Addendum #2 - Issued October 1, 2012

Regarding Bids for **Pre-Engineered Metal Building System (ITB 12-026P)** for Lucas County Engineer Road Maintenance, bid opening scheduled for October 4, 2012.

ADDENDUM NO. 02

Lucas County Road Maintenance Building
Bid Package #12-026P – Pre-Engineered Metal Building System
Dated 9/28/2012

SHEET NO.
A1.03

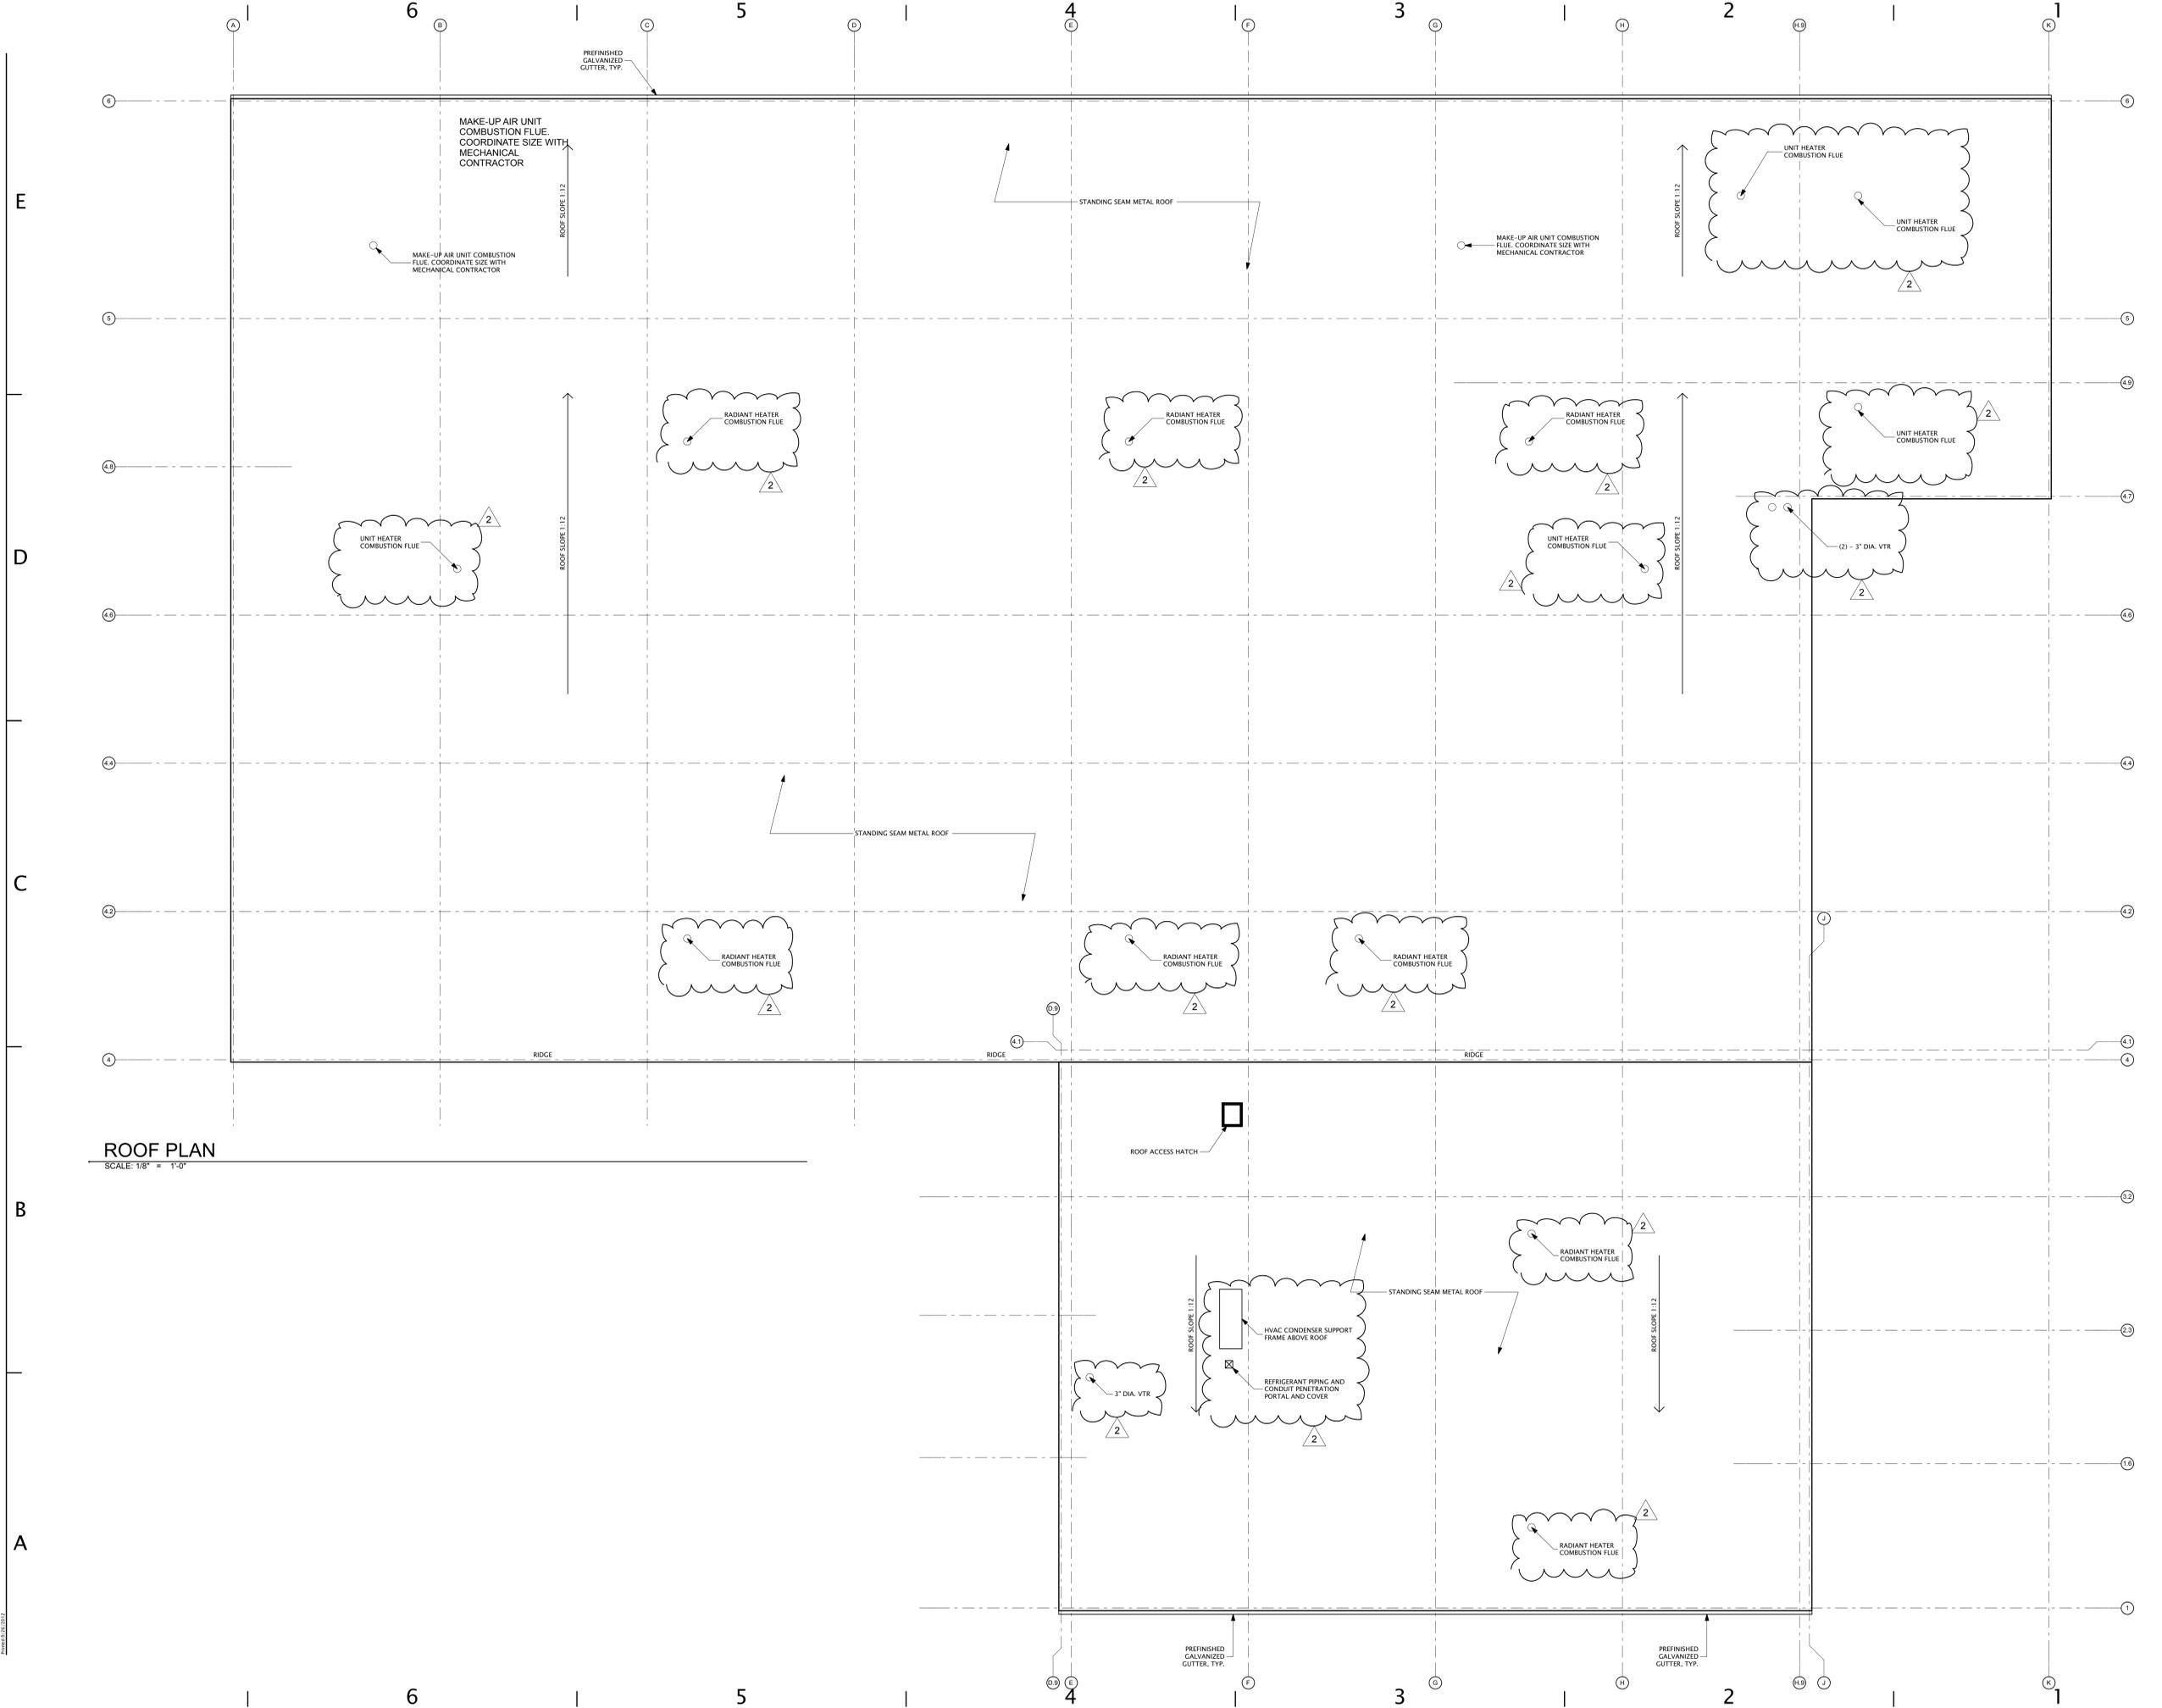
- b) Question: Is the roof slope 1:12 or 2:12 at the Repairs Building (the elevations show 1:12 on sheet A4.01 and the roof plan shows 2:12 on sheet A1.03 at this area)?

Answer: No. Refer to Sheet A1.03 included with this Addendum for roof penetrations.

Drawing A1.03 "Roof Plan" – Re-Issued

- Item #1 Added locations of roof penetrations for unit and radiant heater combustion flues, plumbing vents-through-roof and roof-top mounted HVAC condenser units and pipe penetration enclosure.
- Item #2 Corrected all metal roof slopes to read "1:12".

Answer: All metal building roof slopes are 1:12. Sheet A1.03 has been revised and re-issued with this corrected.

A4.11 WALL SECTION
 SCALE: 3/4" = 1'-0"

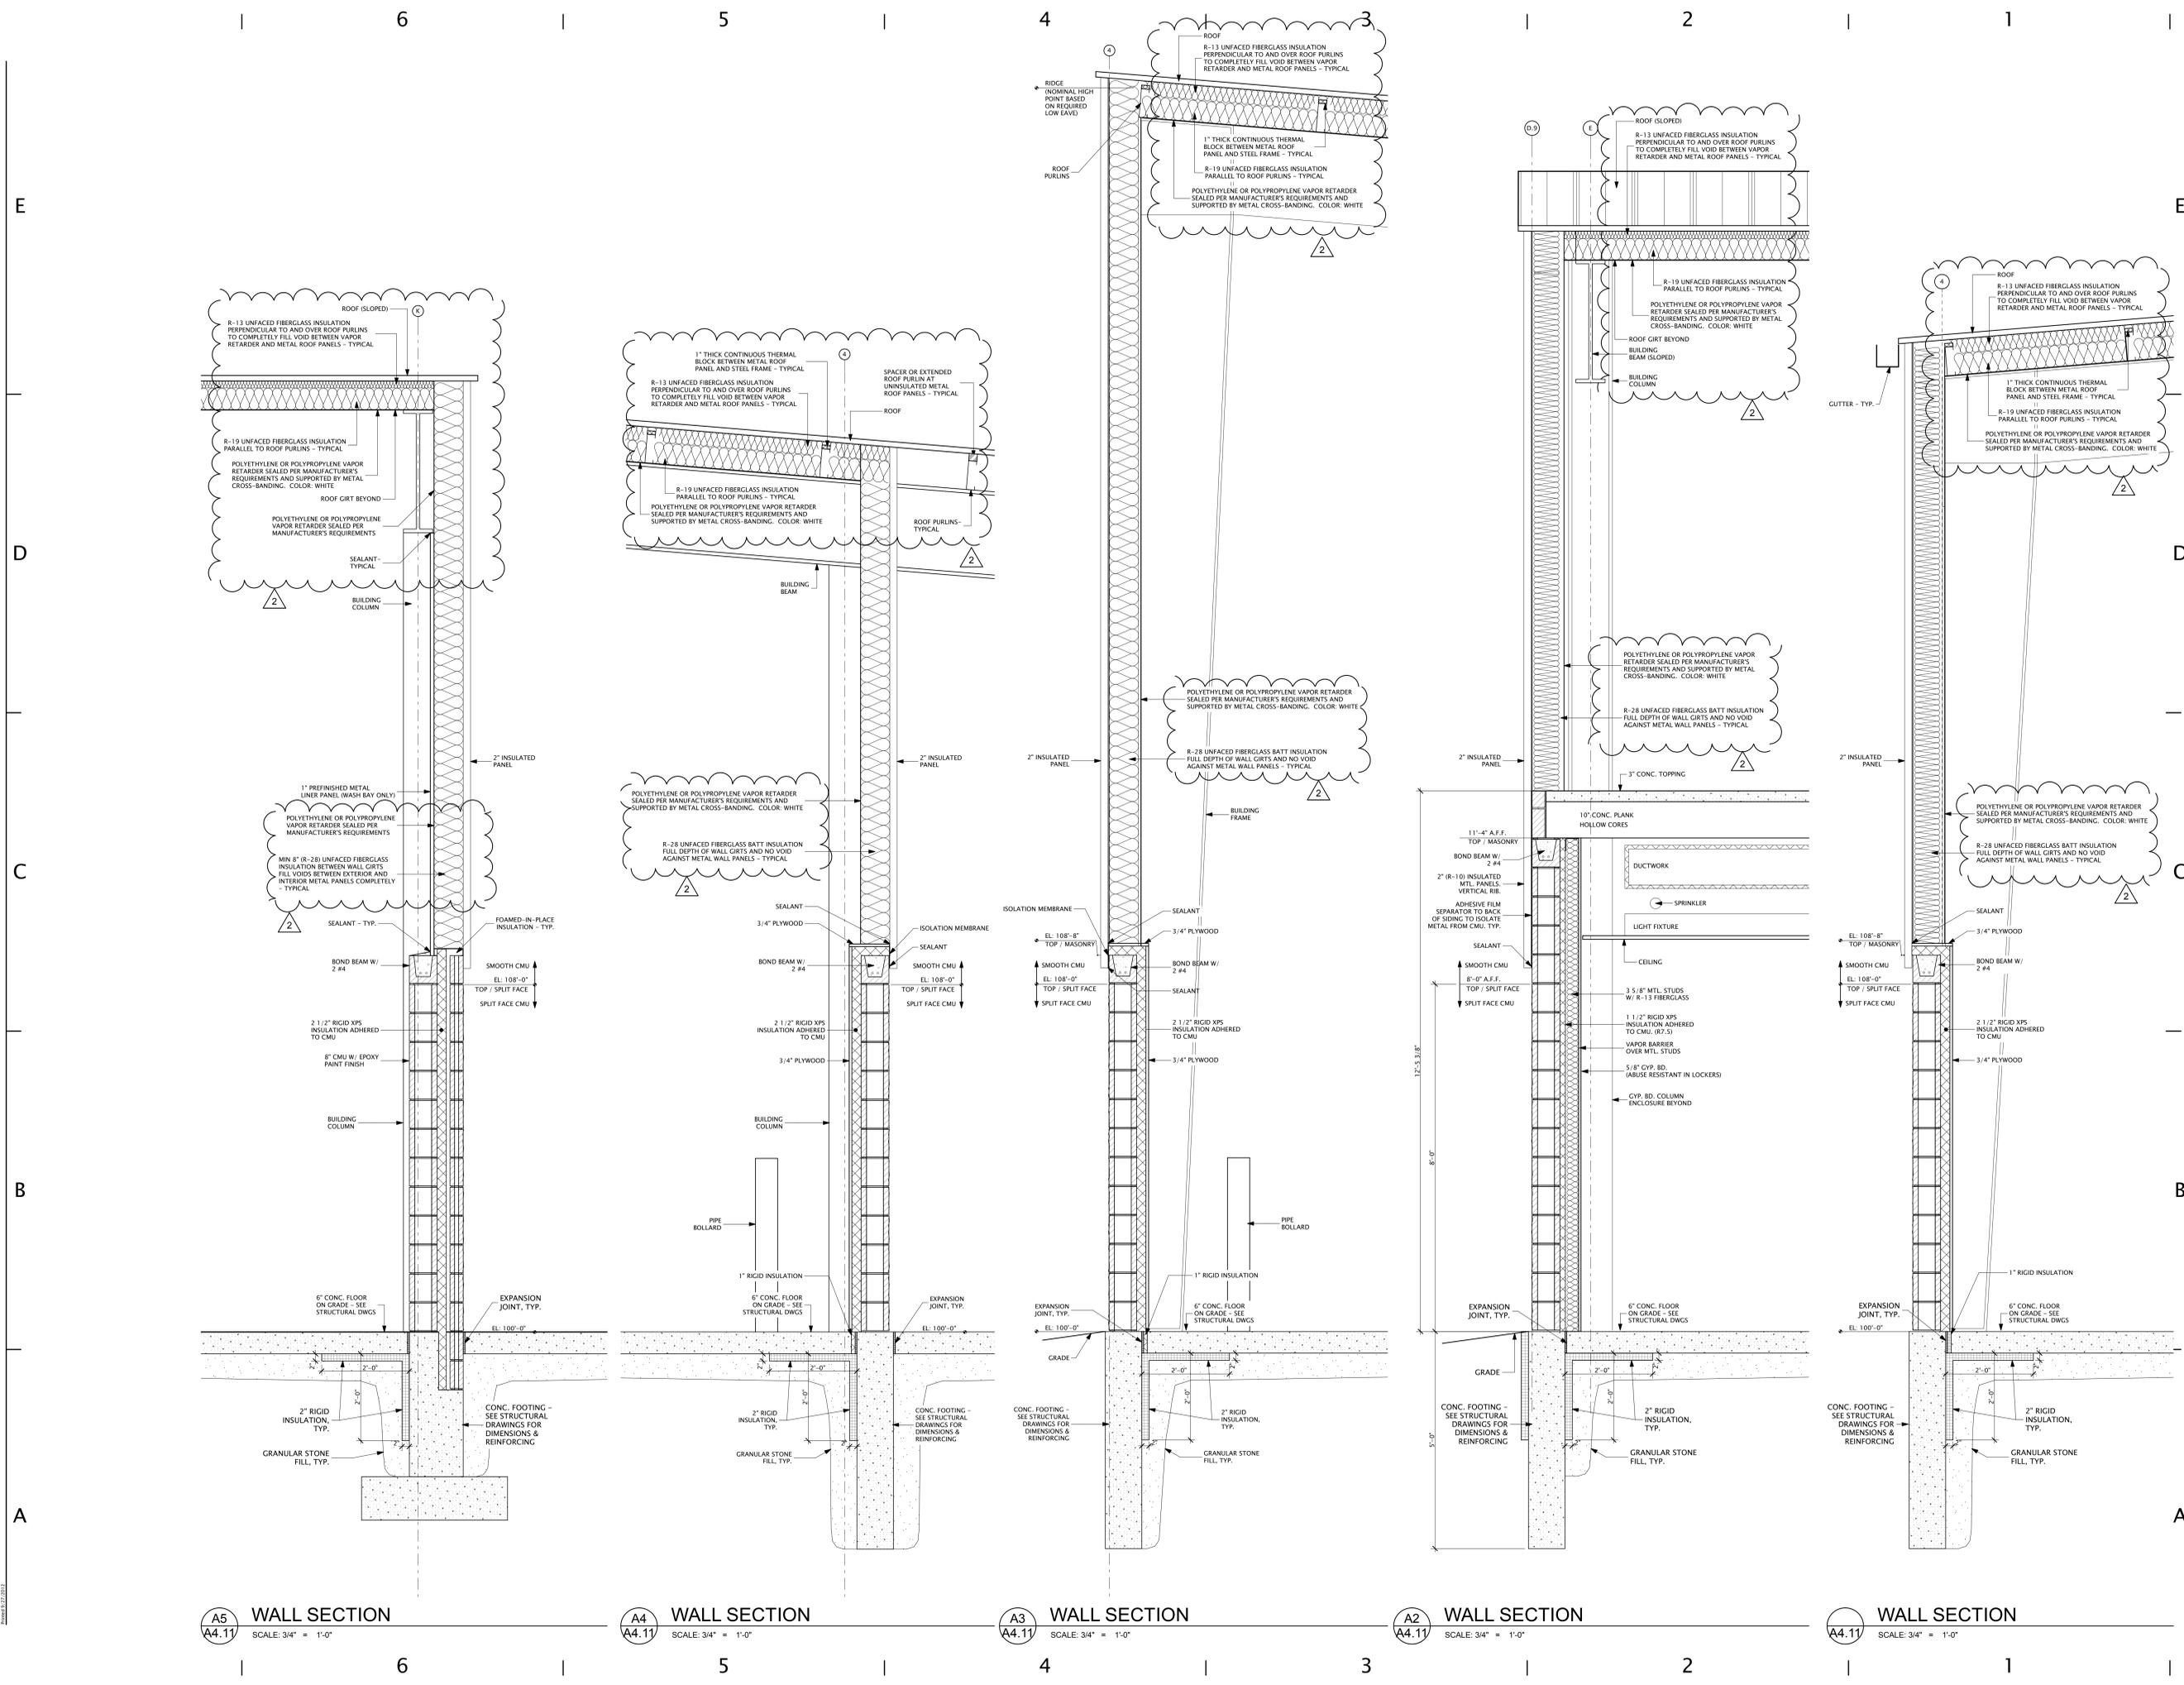
- d) Question: The insulation specifications are ambiguous. Is the roof insulation to be 8" thick (R25) or 12" thick (R38)? What is specified roof insulation system; Simple Saver system or "sag & bag" system? What type of insulation facing is required - do they want a typical reinforced white scrim, i.e. WMP10?

Drawing A4.11 "Wall Sections" – Re-Issued

- Item #1 Revised wall sections to indicate intended configuration of metal building system roof and wall insulation materials.

Answer: The insulation details and specification are changed in this Addendum to clarify the minimum insulation "R" values and the methods of installation. Refer to included specification revisions and drawings for requirements.
